YANKEE ATOMIC ELECTRIC COMPANY

Subject: Response to Requests for Additional Information, SEP
Topics III-2 and III-4.A

ENCLOSURE 1

Response to Enclosure 2 of Letter, J. W. Clifford (NRC) to
G. Papanic, Jr. (YAEC), dated March 14, 1986 (NYR 86-055)

PRIMARY VENT STACK
SUPPORT @ ELEV. 1058'2"
FIGURE 1-4, SH. 10F.3

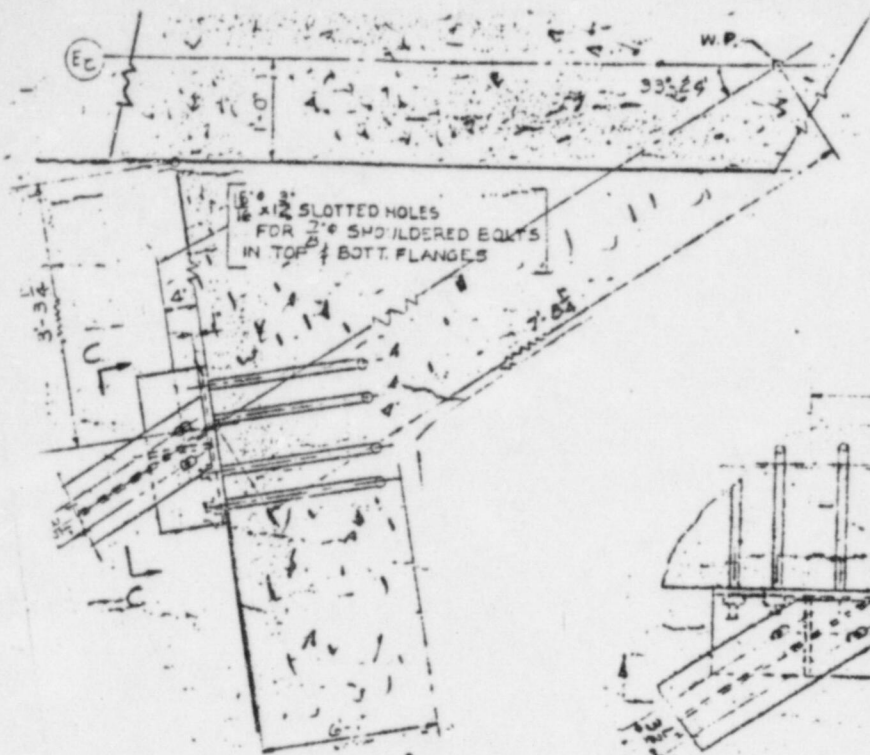
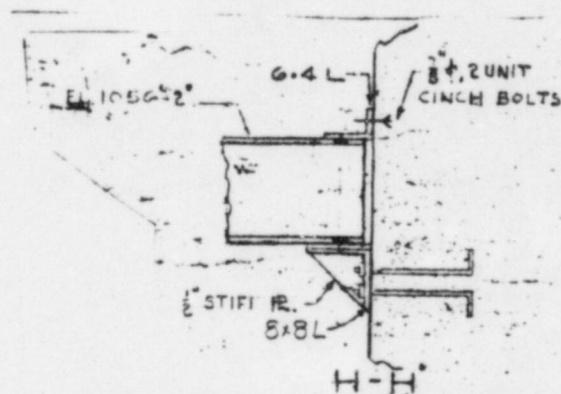
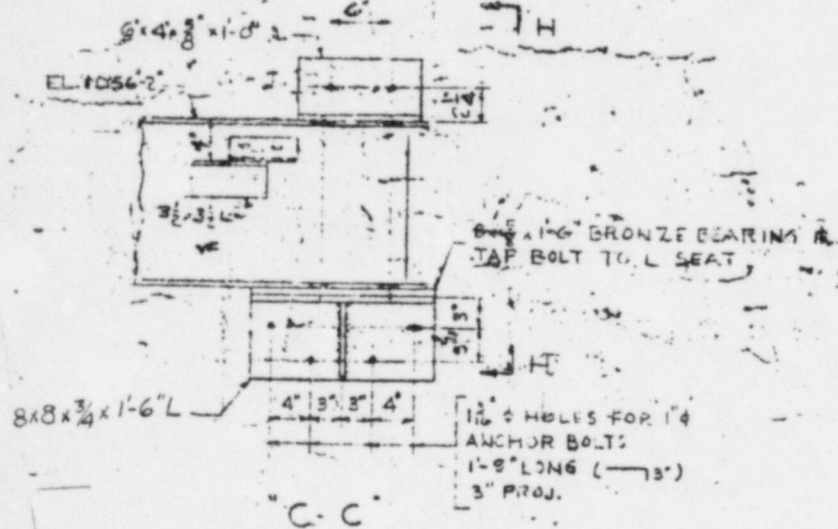
The chimney is a steel stack, 5'-0" in diameter and 1/4" thick. It was identified in NRC's IPSAR (NUREG-0825) as a concern, but was not addressed in the licensee's submittals. Provide schedules to submit the results of the chimney's analysis.

The primary vent stack is approximately 130 feet tall and is supported at two elevations. The base of the stack is restrained vertically and laterally at Elevation 1056'-2". The support at Elevation 1131'-0" provides lateral restraint. An elevation view of the stack is shown in Figure 1-3. The support at Elevation 1056'-2" is shown in Figure 1-4. Figure 1-5 presents the support at Elevation 1131'-0".

FIGURE 2-4
DGB - Schematic Plan View

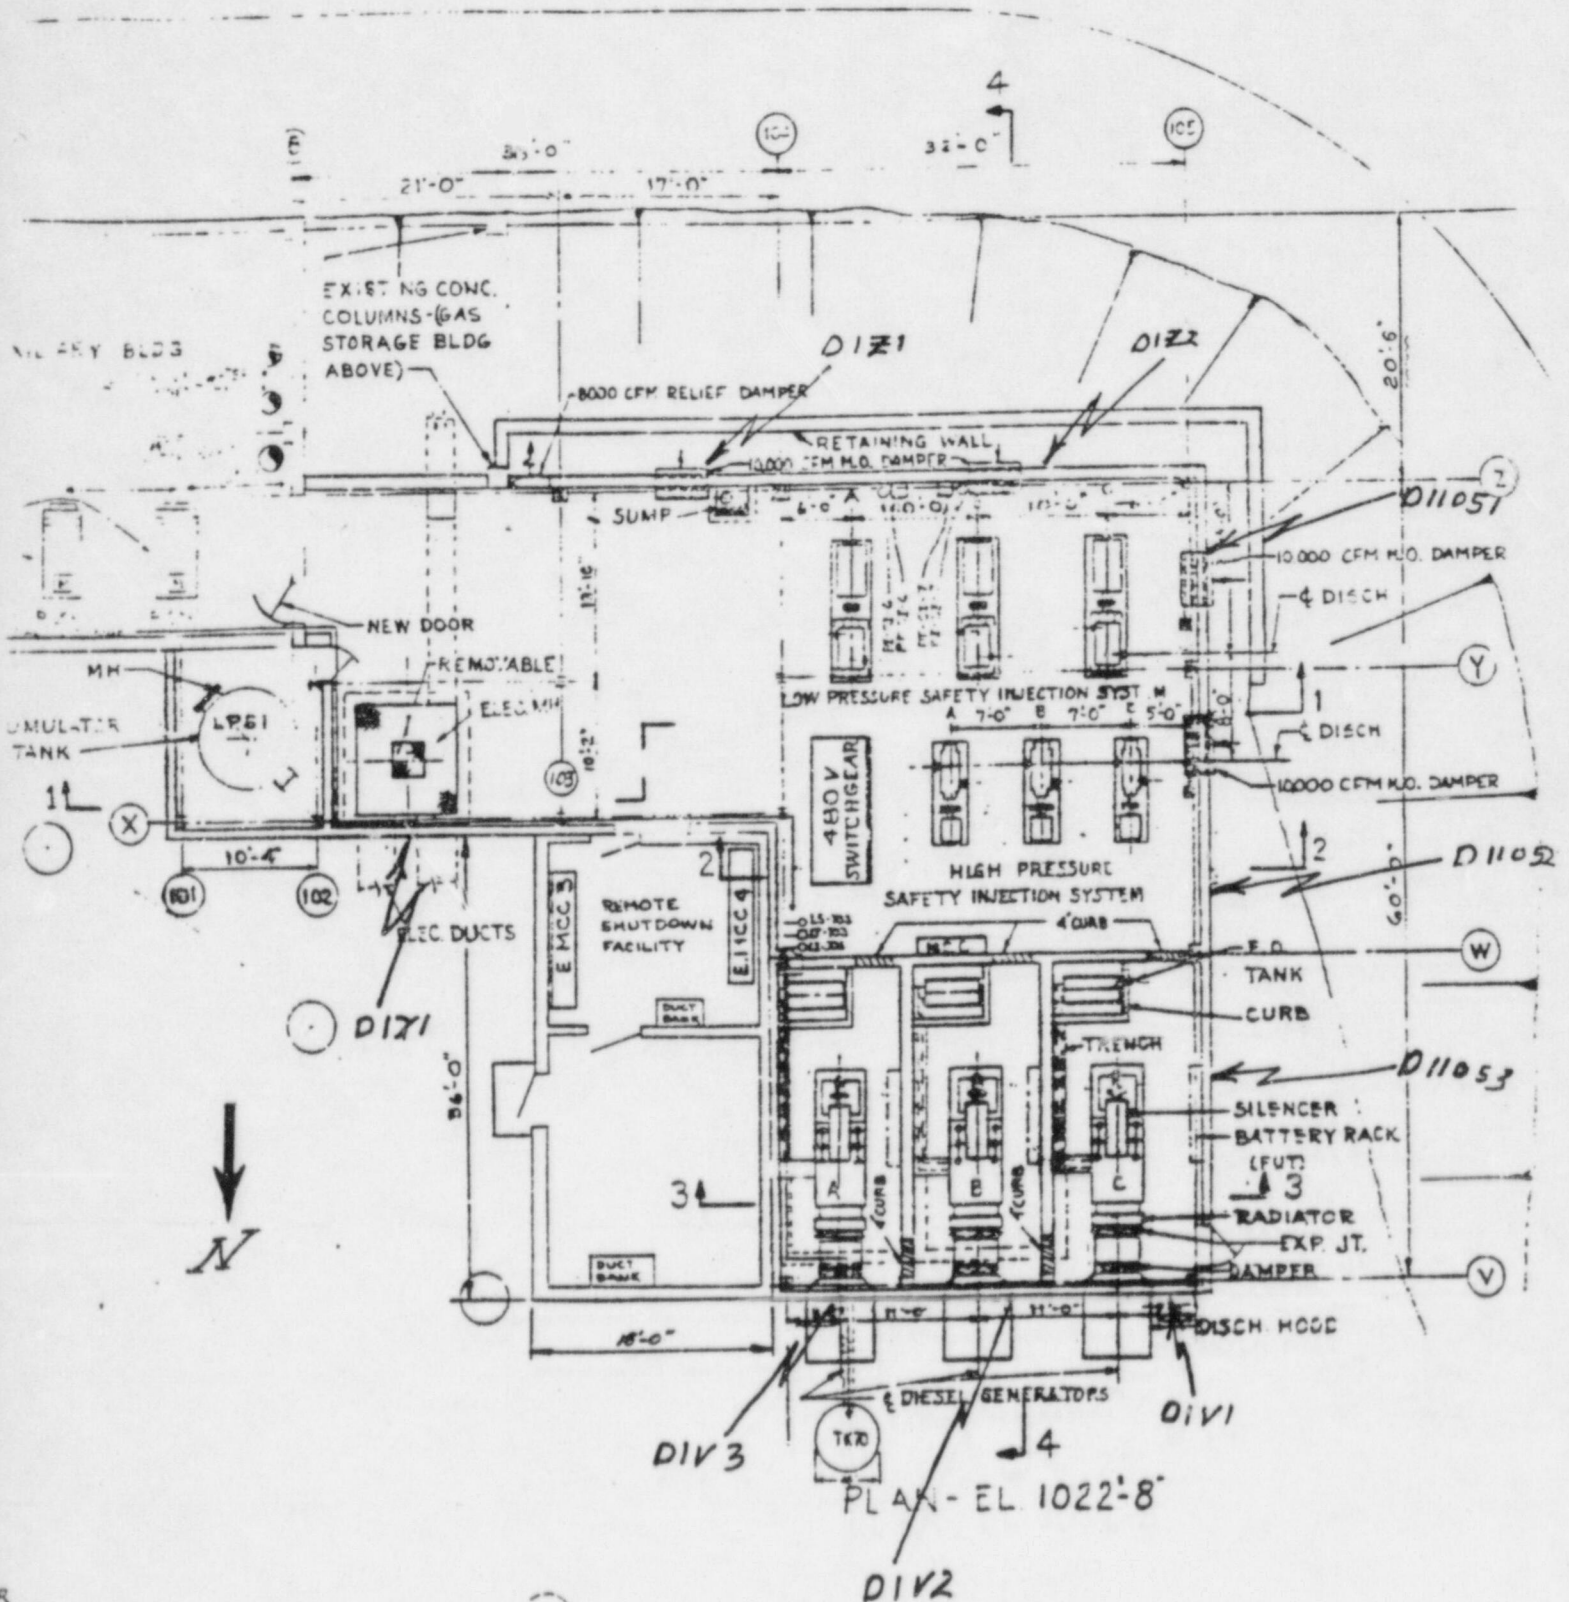
Below is a discussion of the specific interior walls listed in Question 10:

Diesel Generator Building West Wall, D11053, and North Walls D1V1, D1V2, and D1V3 - A plan view of the Diesel Generator Building (DGB) is presented in Figure 2-4. This figure shows equipment locations and wall designations. The effect of the failure of each wall section in the DGB is discussed below:

FIGURE 4-1

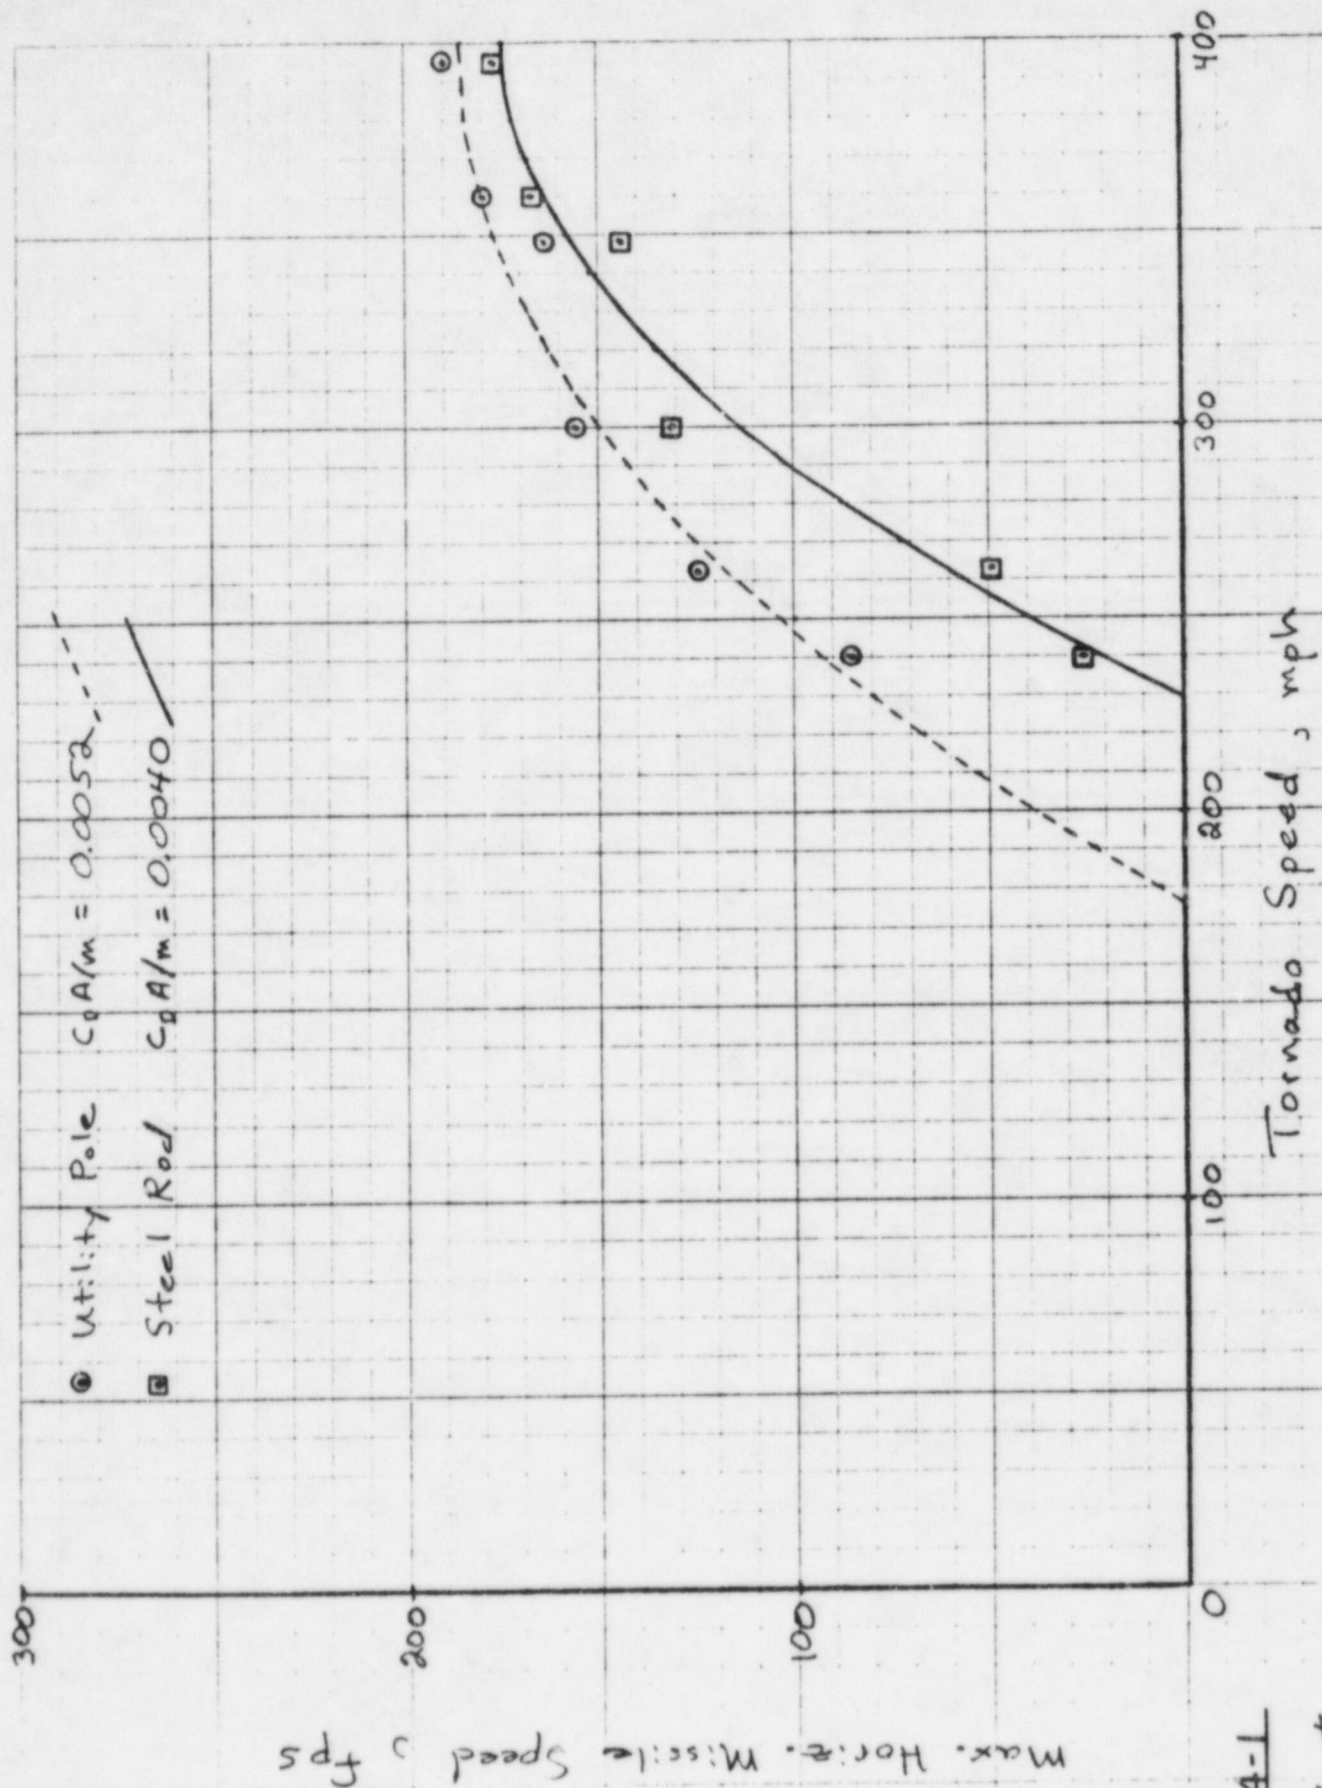
Provide technical basis for extrapolating the missile speed beyond the range of the tornado windspeed between 240 mph and 360 mph.

Results of an additional analysis are presented here in Figure 4-1. From Figure 3 of Reference 4-1, maximum horizontal missile speeds as a function of $C_D A/m$ for six levels of tornado windspeeds are available. Maximum

The least square polynomial curves along with the data points are shown in Figure 4-1. The coefficient of determination, R^2 , for the curves are 0.96 and 0.97 for the utility pole and steel rod, respectively. These high R^2 's indicate a good fit to the data. Extrapolation of missile speeds below the 240 mph tornado from the Figure 4-1 curves confirms the Reference 4-3 conclusions that neither the steel rod nor the utility pole would be potential airborne tornado missiles for tornado wind speeds associated with the 10^{-4} and 10^{-5} upper 95 percent confidence interval.
